DELEGATED APPLICATION REPORT

Address: Land at Kenavon Drive, Reading

Application No: 200888/NMA

Proposal: Non-material amendments to permission 170509 (granted on 10/10/2018) to alter landscaping, access design and associated alterations

Proposed Arrival Square Detail Plan

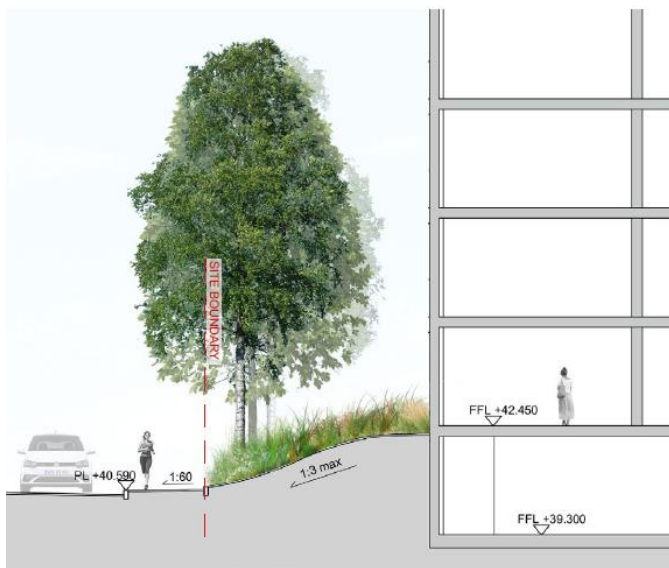
This area remains largely the same. The boundary tree planting include liquidamber trees and a landmark feature oak tree. This provides distinction to the arrival area, but still ensures good visibility from the street into the square.

- Arrival Sq - the change is from 3 individual Liquidambar trees to a stilted/raised canopy Hornbeam hedge. Our revised tree strategy emphasises the need to provide large canopy trees where feasible for the multiple benefits they provide; benefits not obtained from a raised hedge. I am not clear on the reason for the change? It would seem to be for aesthetic reasons only, creating a more formal, ornamental planting to the arrival square and will be a stark contrast to the tree planting that continues in either direction around the perimeter - the north elevation Rev C drawing illustrates this point well I think. I don't see this as a positive change.

Proposed Forbury Road Edge Section

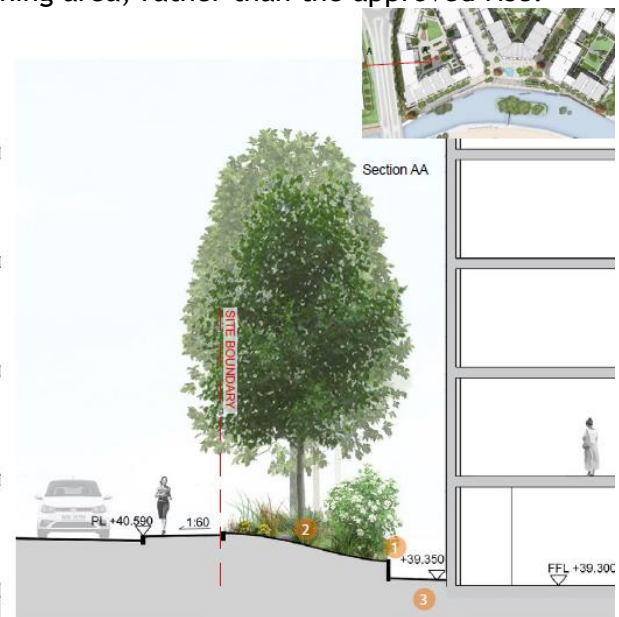
- Additional planting along the Forbury Road edge and there being a drop in level down to the undercroft parking area, rather than the approved rise.

- Forbury Rd frontage - it appears that additional trees and planting has been included and the ground level changes from sloping up towards the building to downward to a maintenance path (to aid air circulation into car park I believe). It could arguably make the landscaping at ground level less prominent by sloping away from the street, hence reduce the impact of this landscape strip - however, it is likely to be possible to mitigate this with use of larger shrubs to give more height. I note that the 'Forbury Road edge section' drawing shows the now proposed section with a more fastigate tree - why is this? No fastigate species is proposed in the tree strategy. See comments on tree strategy changes below.

- Forbury Road frontage - this has changed from alternating Birch and Hornbeam to all Hornbeam - why?
- The plan still lists Liquidambar as a feature tree but none are shown - their omission is acceptable as a non-native with no wildlife value. They are still noted in the Landscape comparison document.

Proposed East Block Podium

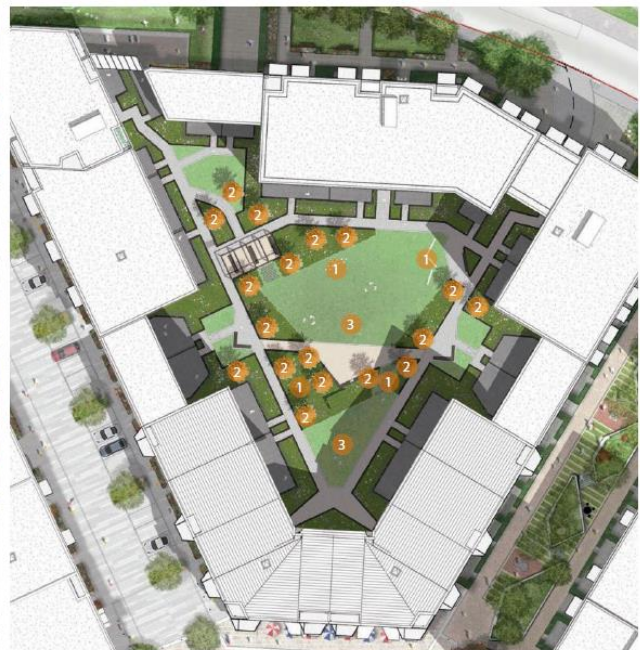
The East Block Podium proposal remains similar to that approved with required rearrangements coming as an offset from adhering to structural requirements and movement routes to comply with fire regulations. Seating areas, a mixture of hard surfaces and soft surfaces spaces reoccur alongside the 2 areas of play and an overall increase in trees and lawn to allow for increased biodiversity and spaces for play and relaxation.

In relation to the east block, comparing Rev E Illustrative Masterplan (below left) with the revised Rev F (below right), this shows an overall increase in soft landscaping hence I have no objections.

- P35 & P36 East and mid block podiums - these show the increase in tree planting proposed. There is no plan for the west podium, which the applicant has confirmed is unchanged. Planting as shown on the Podium GA plans is acceptable.
